**JOINT ARCHITECTURAL BOARD/PLAN COMMISSION AGENDA
MONDAY, DECEMBER 21, 2015
7:00 PM
BOARD ROOM
MUNICIPAL BUILDING, 210 COTTONWOOD AVE.**

Preliminary Storm Water Management Report
Holt Electric Motor, 1515 Walnut Ridge Drive
Village of Hartland, Waukesha Co., WI

PROJECT
HOLT ELECTRIC
WAREHOUSE
EXPANSION

RE: Village of Hartland
Holt Electric – Warehouse Addition - Plan Review Letter

1 PROPOSED NORTH ELEVATION

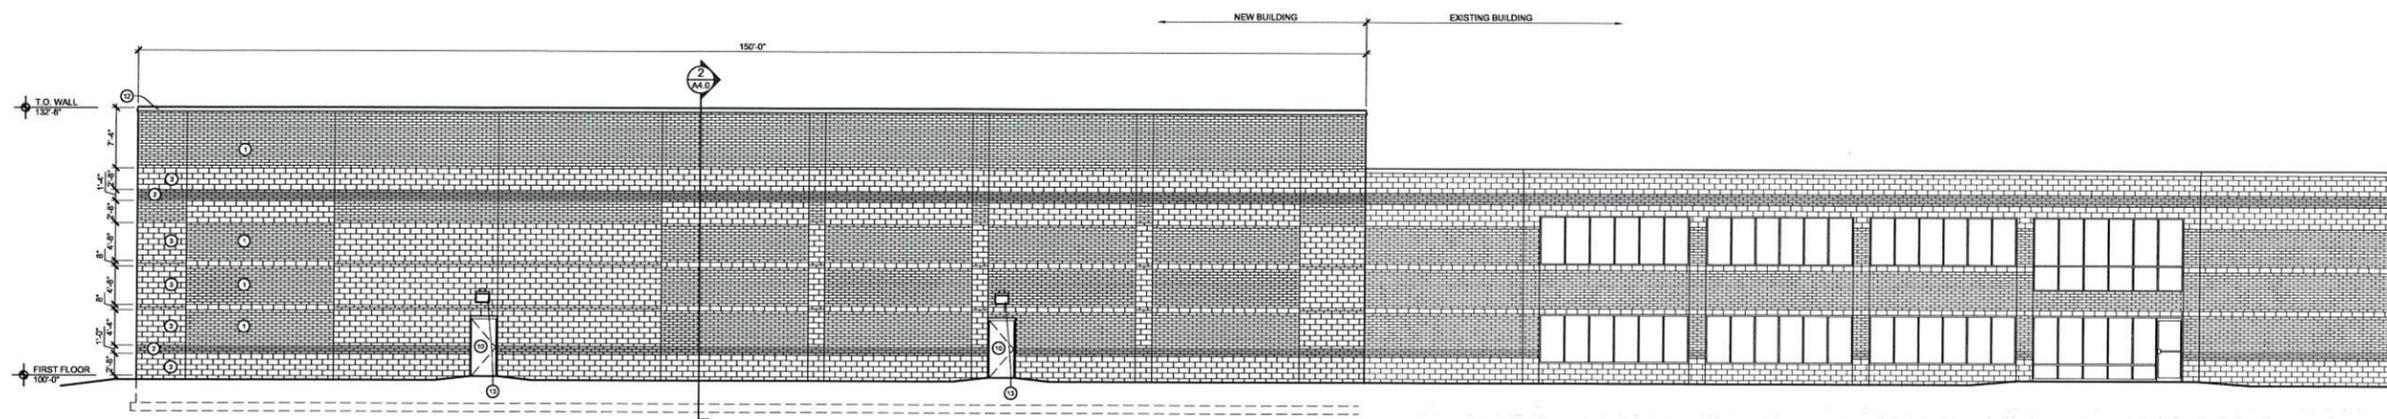
1. Provide windows to break up the blend the façade of the new warehouse space shown on the proposed north elevation view to blend in with the existing building.

CERTIFIED SURVEY MAP NO. _____

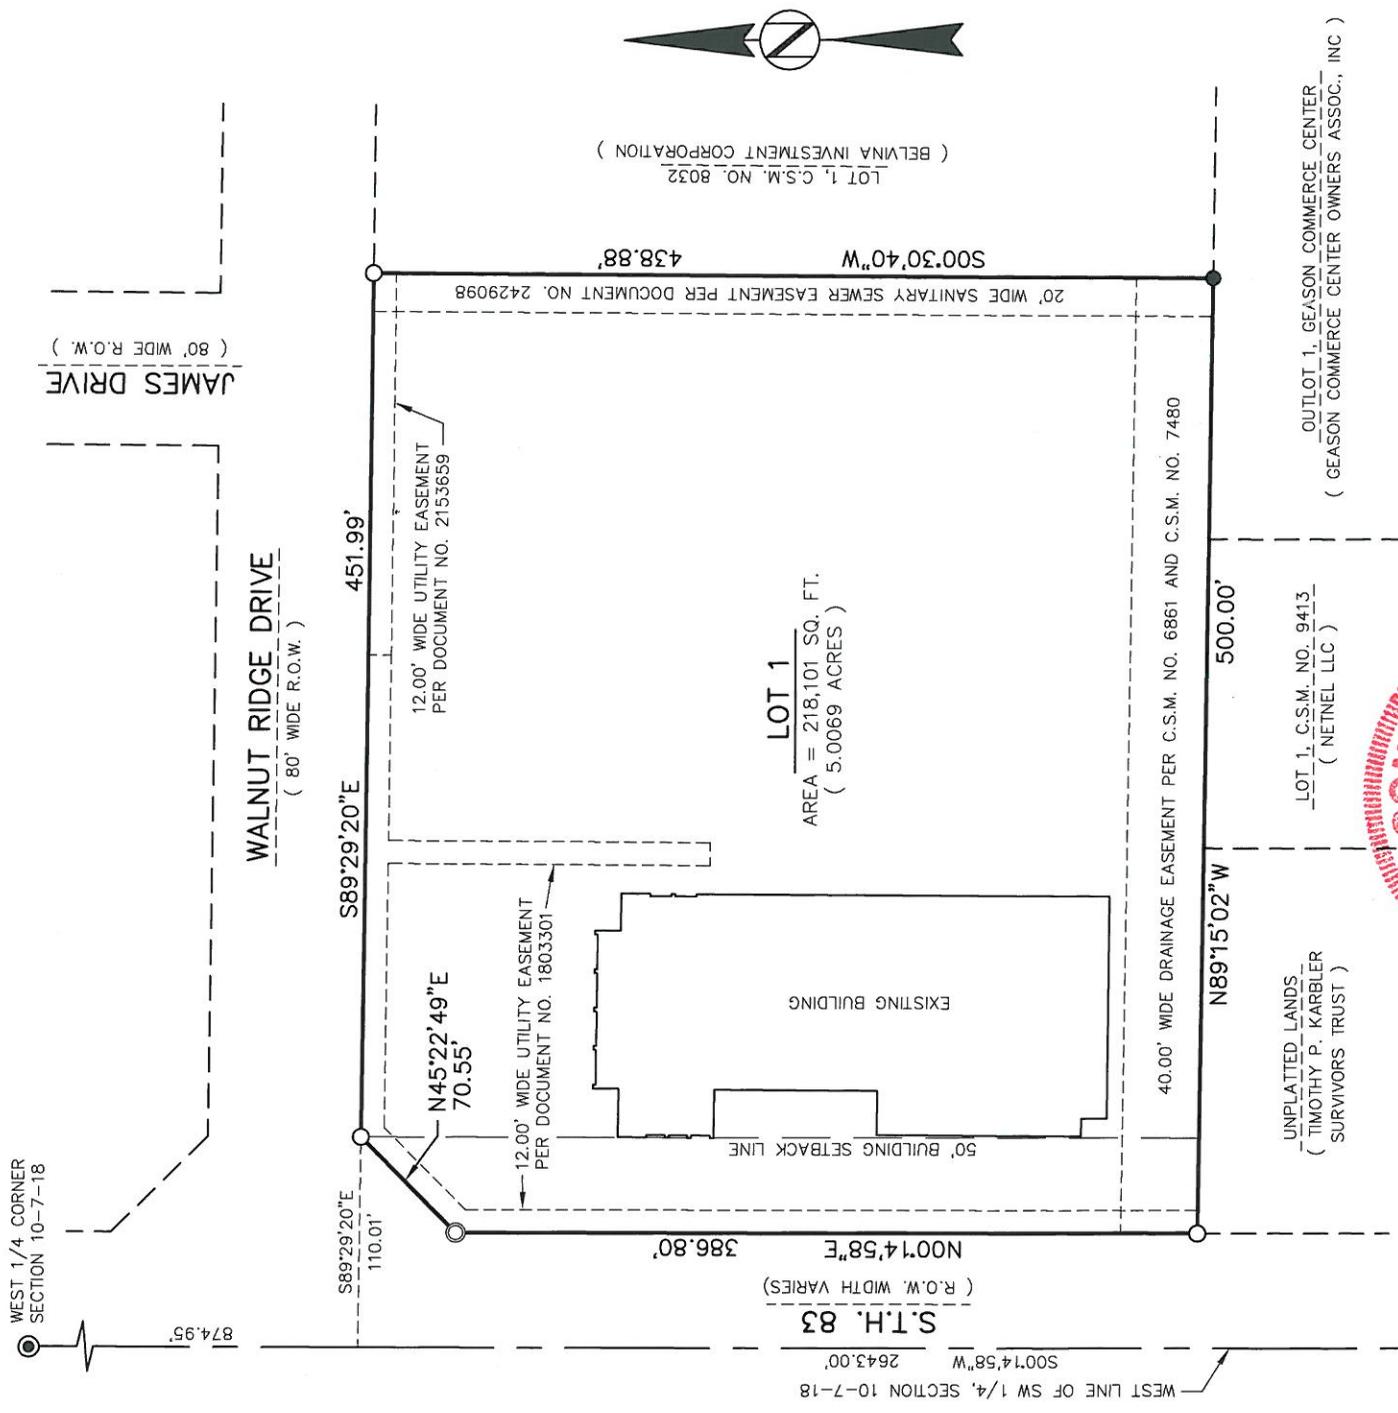
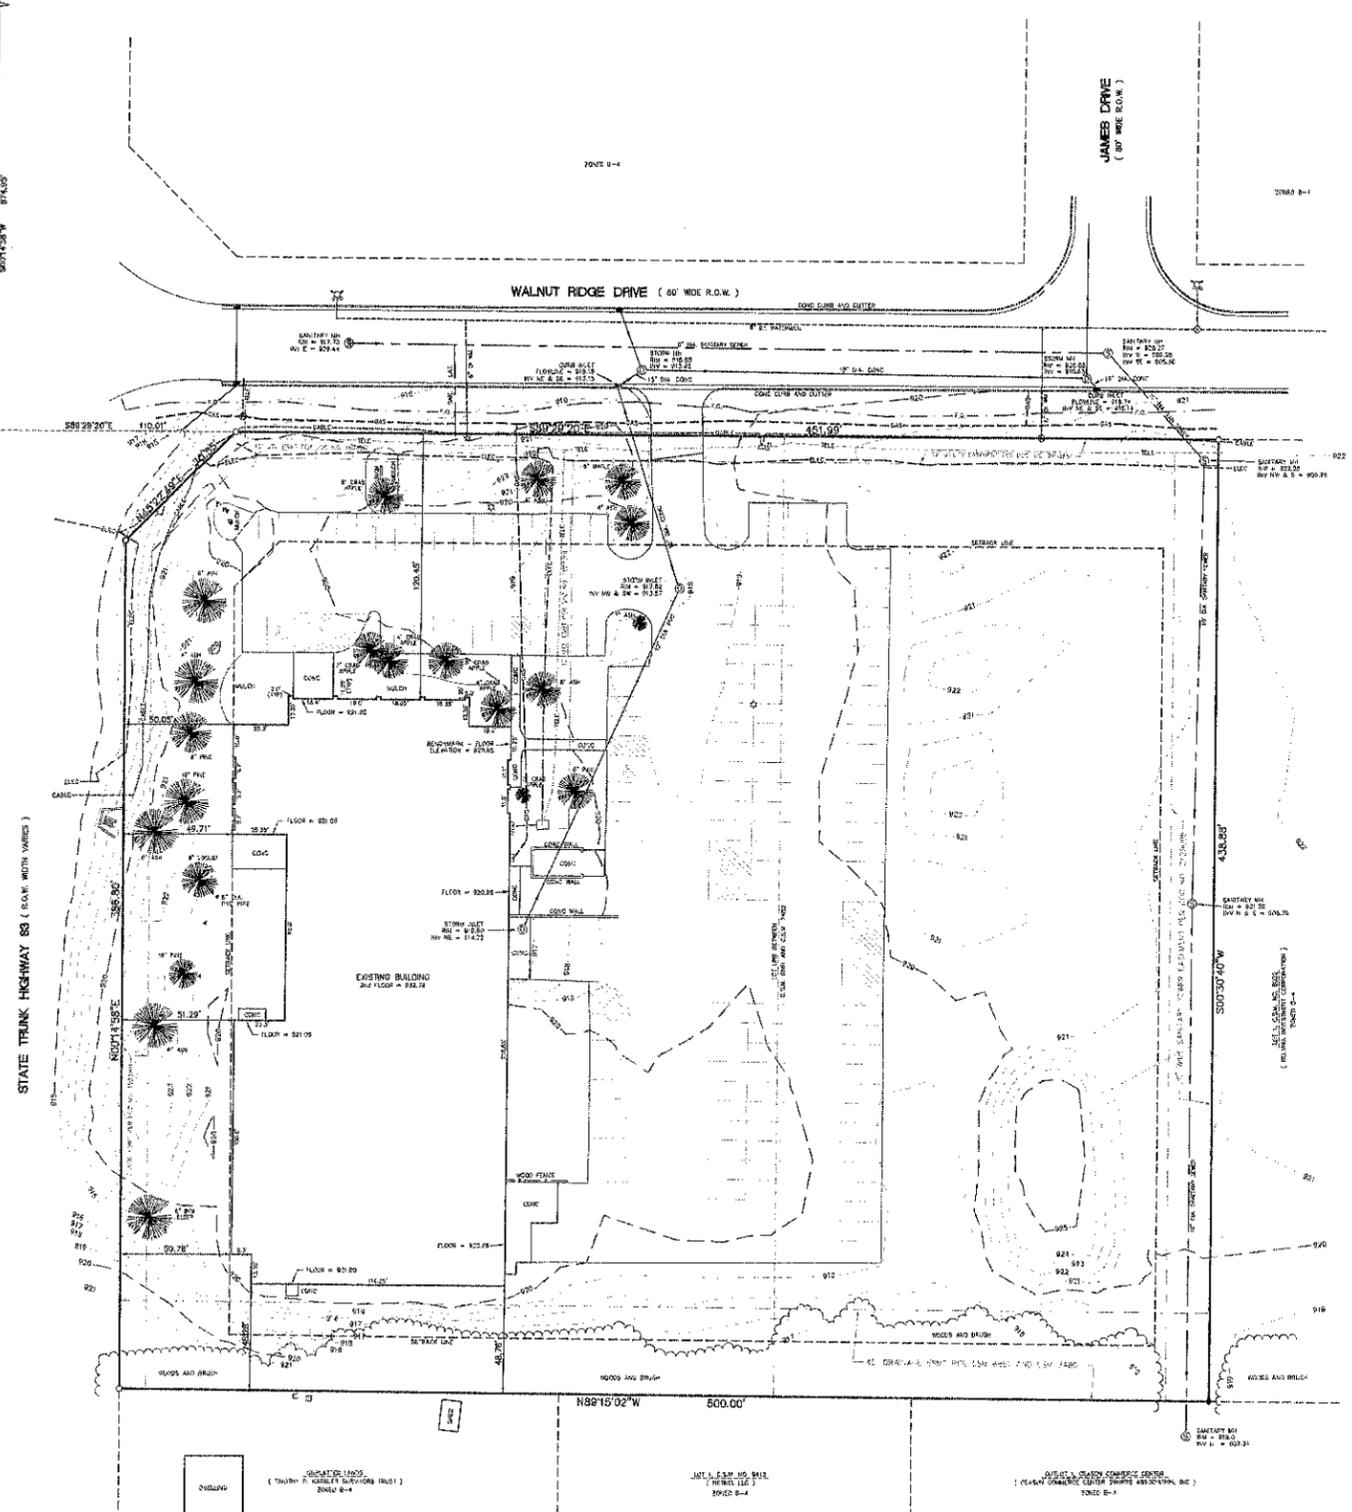
1. Correct the discrepancy between the 386.80 feet distance shown along the west property line on the exhibit and the 386.60 feet distance show in the description.

LANDSCAPE
PLAN

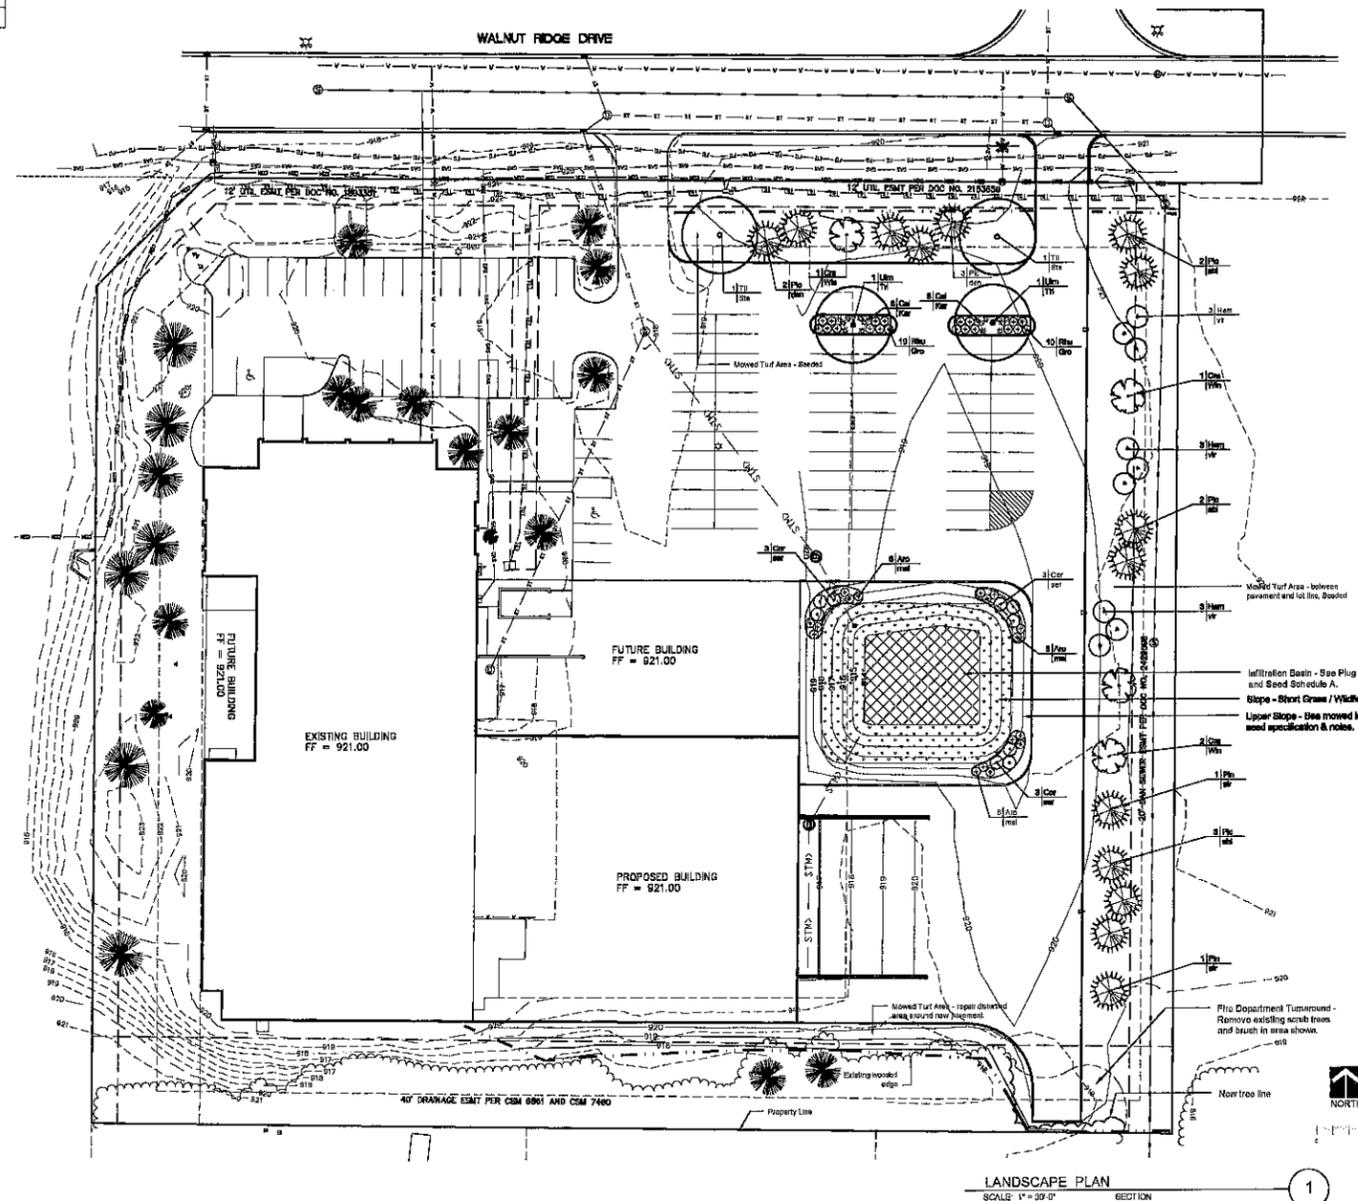
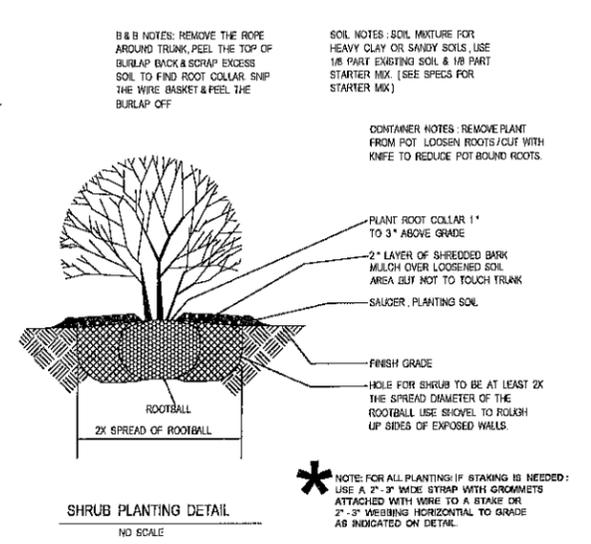
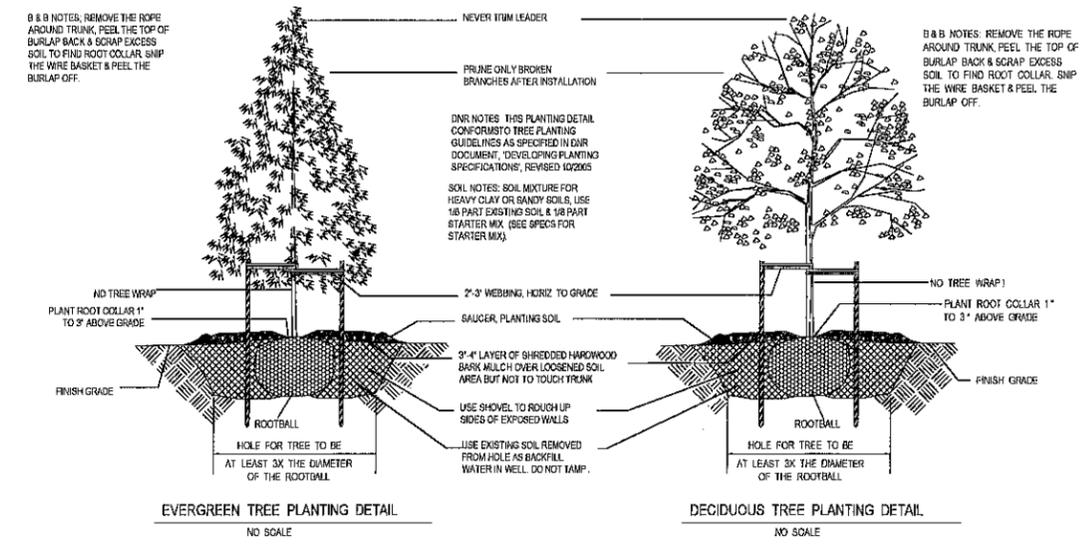
1. Identify existing trees greater than 3-inch in diameter being removed from the site. Provide trees in proximity of the hammer head turn around to screen view from southeast. Obtain tree protection permit.
